**Street Route Accessibility Audit
For
Blessington & District Forum**

Accessibility Audit

BLESSINGTON MAIN STREET, CO WICKLOW

For Blessington & District Forum

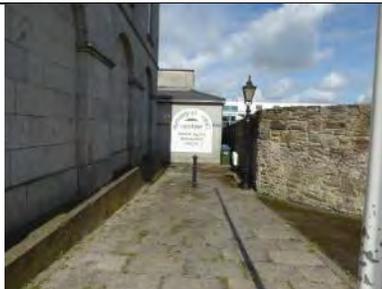
2.13	Controlled Crossing at Murphy's Pub & Dry cleaners	The crossing is identified by red concrete paving laid correctly. However the colour of the paving, as with the buff blister paving throughout the town, has faded and is no longer distinguishable. On the west side of the crossing poor drainage results in ponding at the junction of the road and footpath in the middle of the crossing point.		<p>TGDM 2010</p> <p>1.1.4 Pedestrian crossings</p> <p>Where pedestrian crossings are provided, tactile paving and dropped kerbs should be provided at controlled and uncontrolled pedestrian crossings in accordance with 'Good Practice Guidelines on Accessibility of Streetscapes'.</p>	3

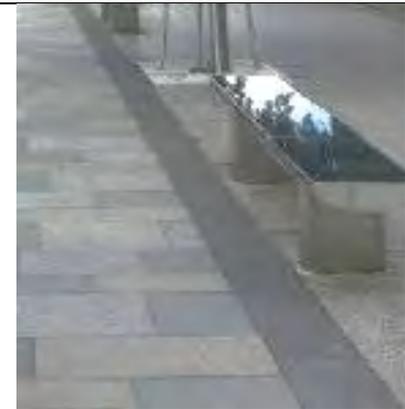
3.16	Cycle Paths	<p>There is no cycle path anywhere in the centre of the town and people with the result that both adults and children were found to cycle on the footpaths.</p>	 	<p>The provision of cycle paths is strongly recommended both to promote healthier lifestyles and reduce car dependency and also to cater for the many visitors and tourists who now visit by bicycle or who may wish to rent bicycles as part of the Greenway initiative.</p>	2

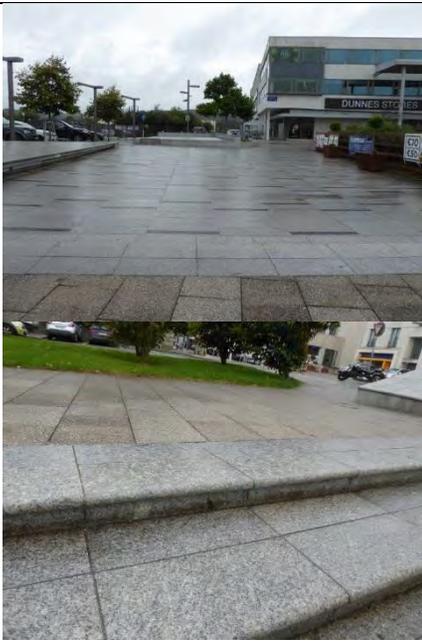
<p>3.17</p>	<p>Public WC</p>	<p>The automated WC was out of order twice during audit inspections and not inspected but visitors were noted struggling with the instructions which were hard to follow.</p> <p>There is no Accessible Change Facility in the town which would facilitate an adult or child with profound or multiple disabilities that needs a toilet facility</p>	 	<p>BS8300-1:2018 A.1.4 Signage Temporary signs and information are particularly important where facilities such aspublic toilets are temporarily out of service. In these cases signs need to be located at points where people can choose an alternative so that they do not have a wasted journey.</p> <p>Refer to Changing Places Ireland for Guidance on Accessible Change facilities or to BS 8300-2:2018.</p> <p>The provision of an Accessible Change Facility would be of great benefit for those who need one and its provision should be registered with Changing Places Ireland and highlighted when promoting Blessington as an inclusive tourist destination.</p>	<p>2</p>
